I just received this email from the FCC. It is your Eyecom C-Band registration for Unalaska Riverside. He wants to change the East SatArc and also wants an Emission Designator. See email below.

From: Jae Lim [mailto:Jae.Lim@fcc.gov] Sent: Friday, February 14, 2020 12:31 PM To: Vanessa Cartwright Subject: SES-REG-20181009-05062; Call Sign: E191440

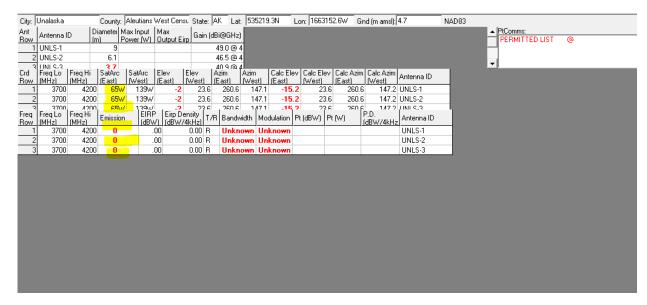
Though 5 degree elevation is not required for receive-only earth station we would like to change East SatArc from 65W to 101W to keep elevation at 5 degrees.

Please check to make sure you have access to your satellite/s in the Permitted List.

We will change your elev and azim accordingly.

Please confirm this change.

The change from 65W to 101W will be fine. Also here is the emission designator
